KOST ENVIRONMENTAL SERVICES, INC.

Re: Glaro, Inc. #1-52-124
Revised Groundwater & Air Sampling Results Report: November 2012

Reference is made to your correspondence of September 26, 2012 regarding comments pertaining to the previously submitted **Groundwater & Air Sampling Results Report: July 2012** and your request for the submission of a revised report and a mitigation work plan.

**For
GLARO, INC.
Site No. 152124
735 Old Willets Path
Hauppauge, New York 11788**

FIGURE 2

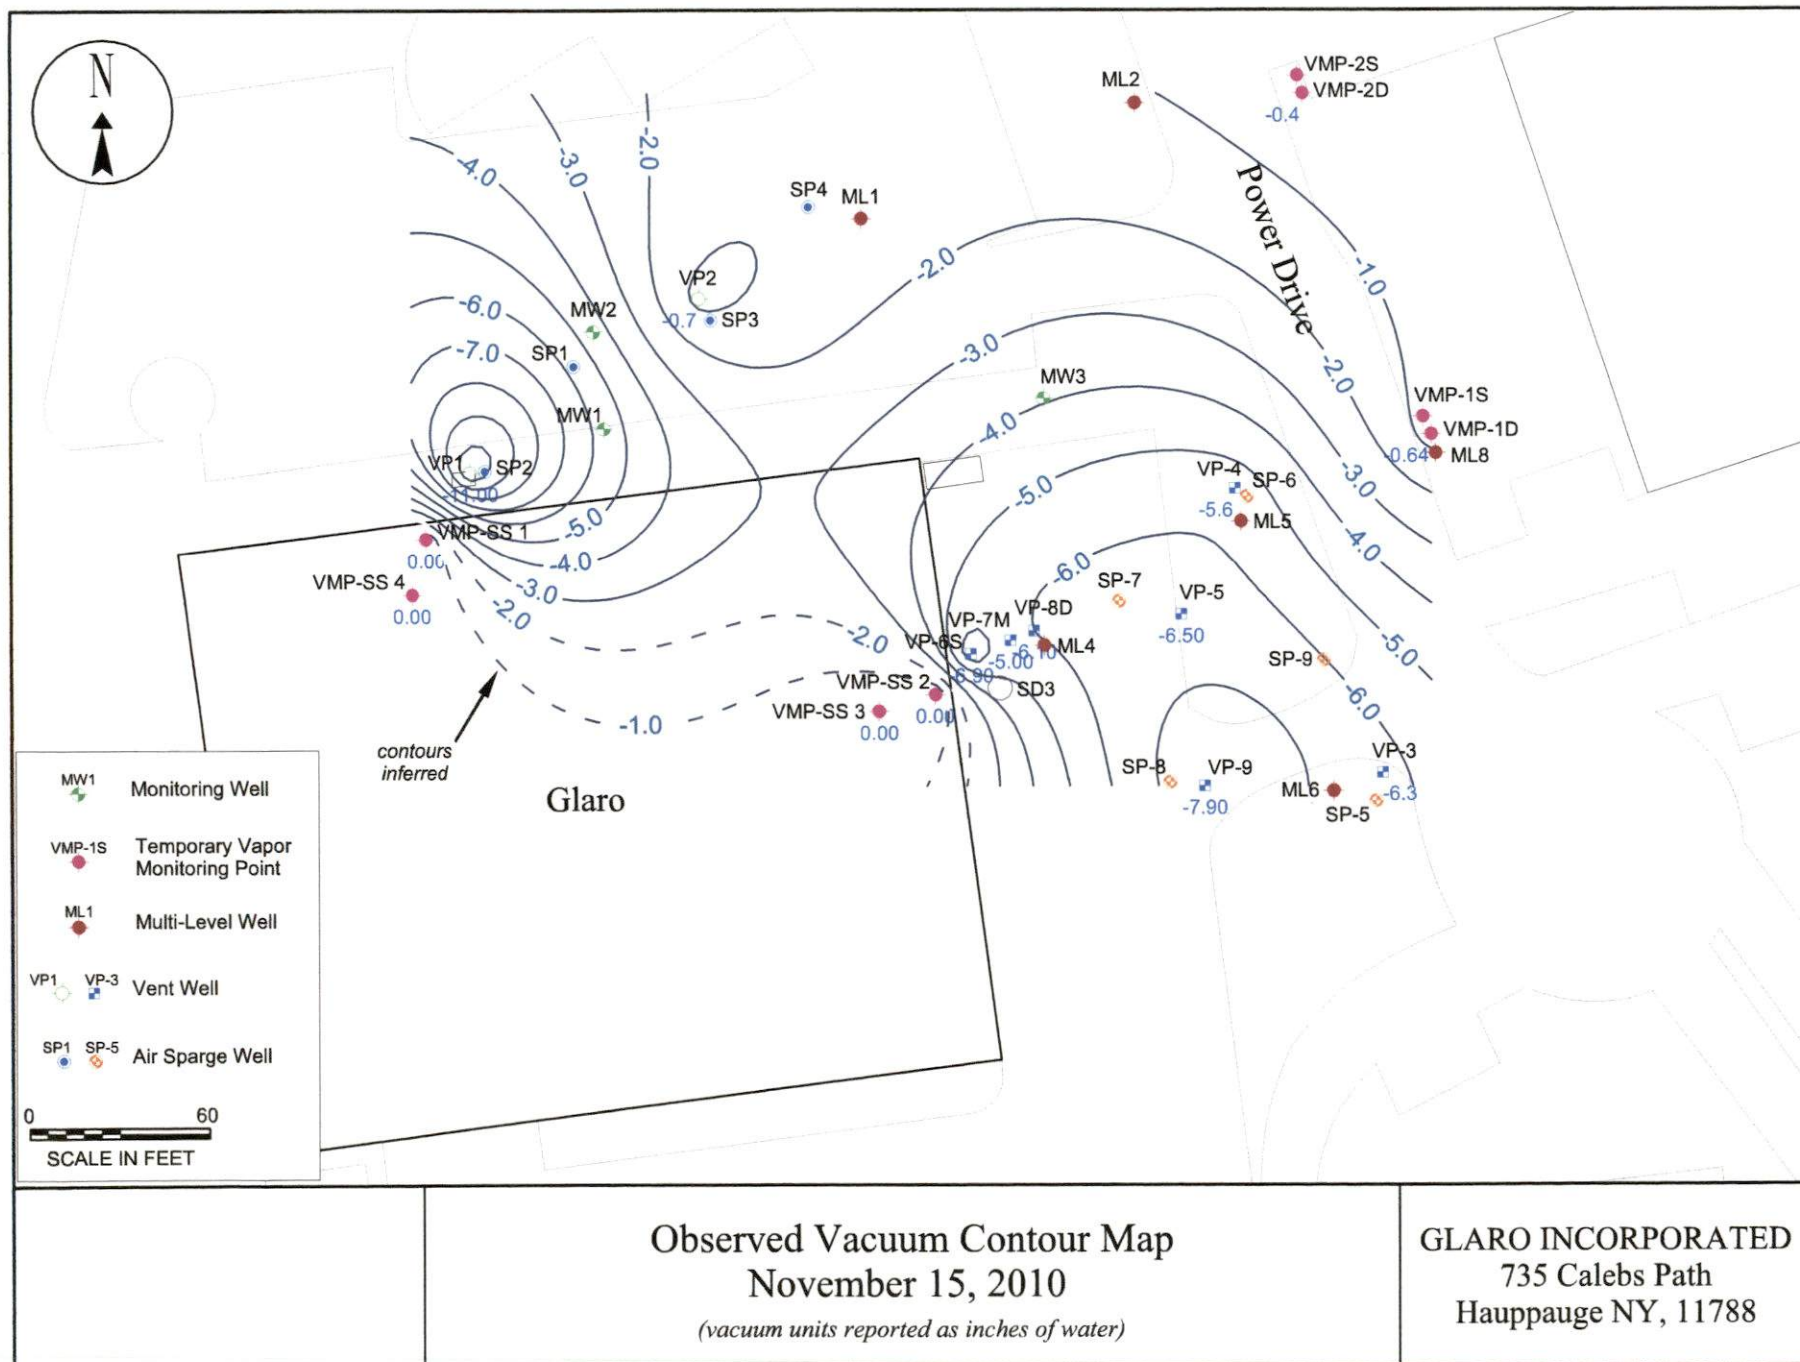
- Please include a figure in the revised report which calculates and describes the zone of influence based upon the vacuum measurements collected with both SVES operational.

Comment: Figure 2 – Vacuum Contour Map, of the revised report indicates the zone of influence based upon vacuum measurements collected on November 15, 2010. Figure 3 indicates the site property boundaries.

FIGURE 3

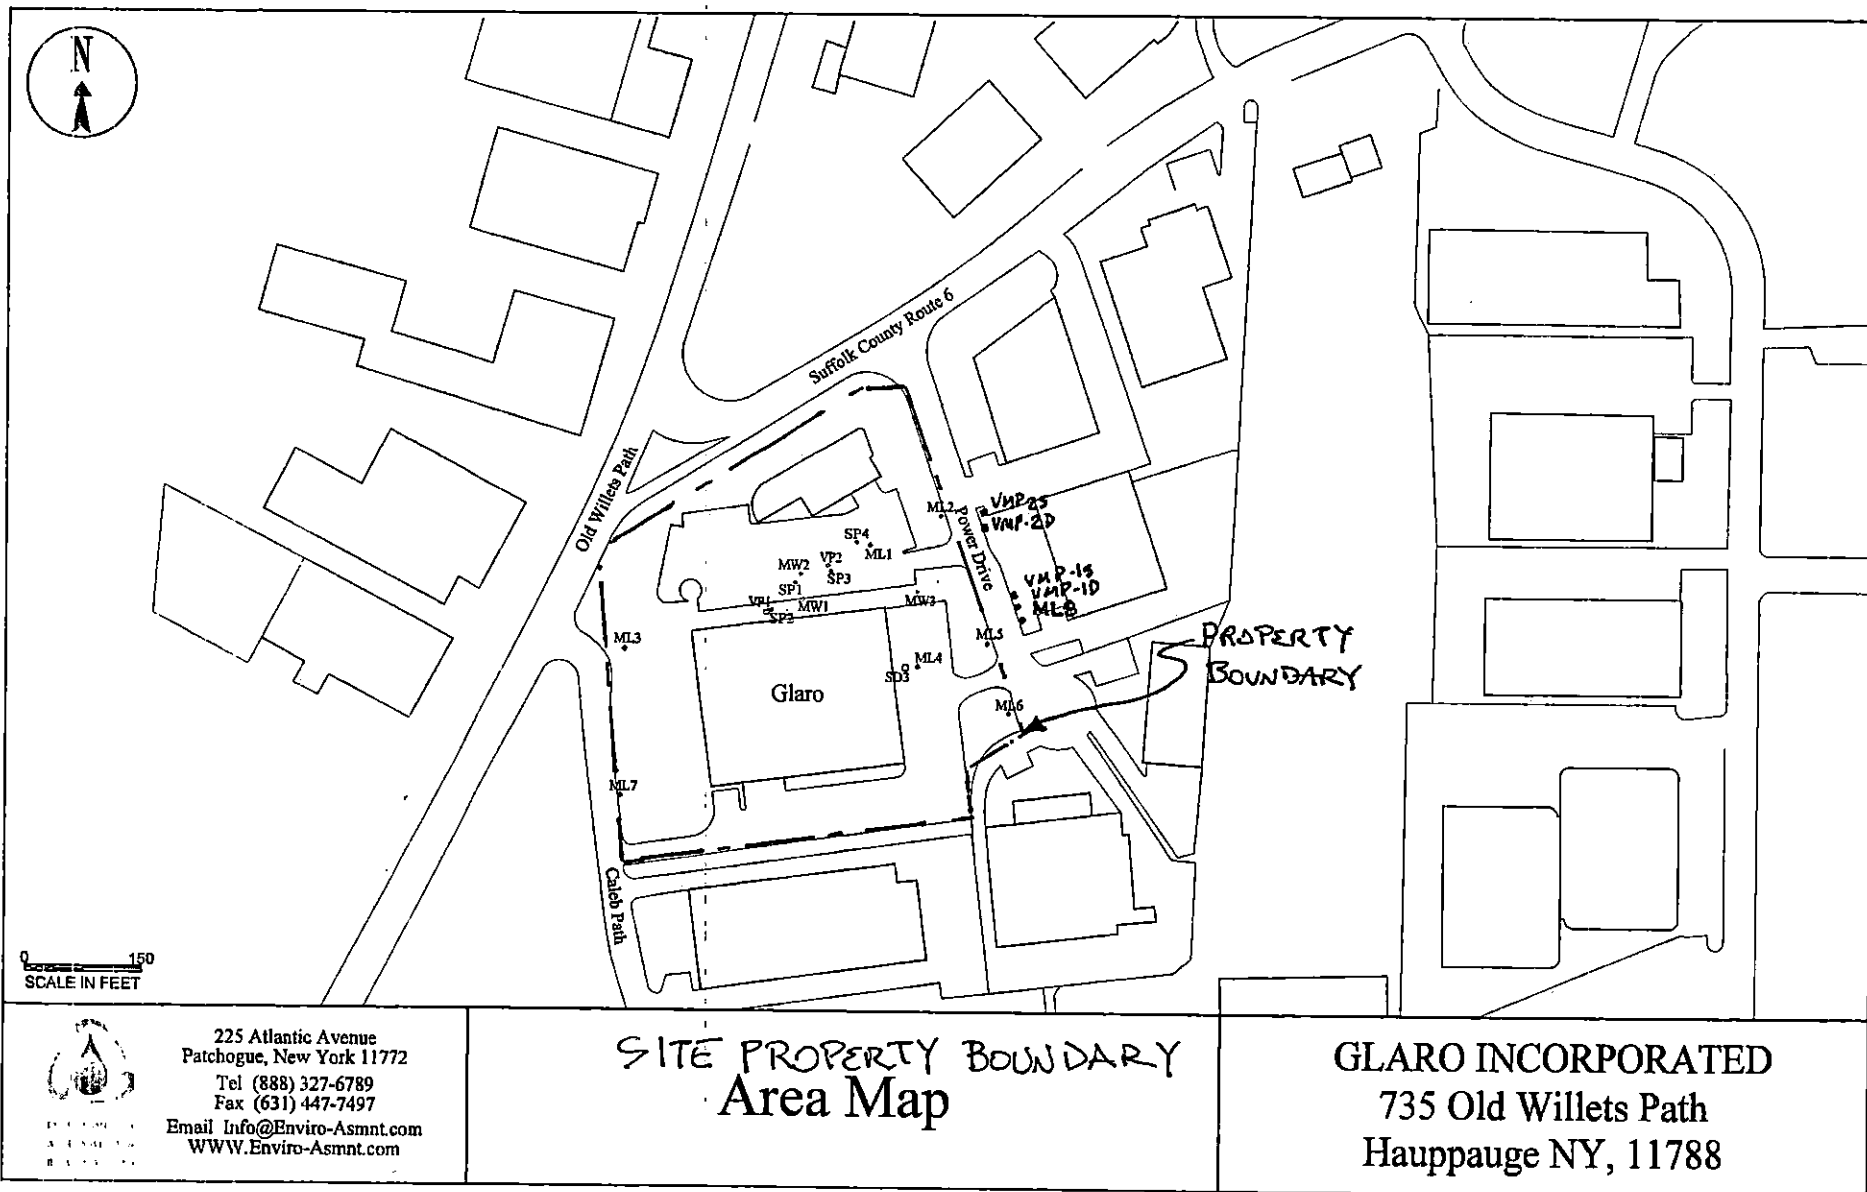
- Please include in the revised report a figure showing the locations of all previously installed exterior soil gas sampling points. Indicate whether they were temporary or permanent points and include a table presenting all sample results. The figure should clearly identify the site property boundaries relative to the building and the soil gas points. The DEC and DOH must make a determination as to whether the exterior soil gas sampling has adequately defined the areal extent of the soil gas plume or whether additional sampling is necessary.

Comment: Figure 3 of the revised report indicate the site property boundaries relative to the building and soil gas points and the locations of all previously installed exterior soil gas sampling points which are all permanent. A table presenting all sample results will be provided shortly as soon as the environmental data is compiled in an approved electronic deliverables format.
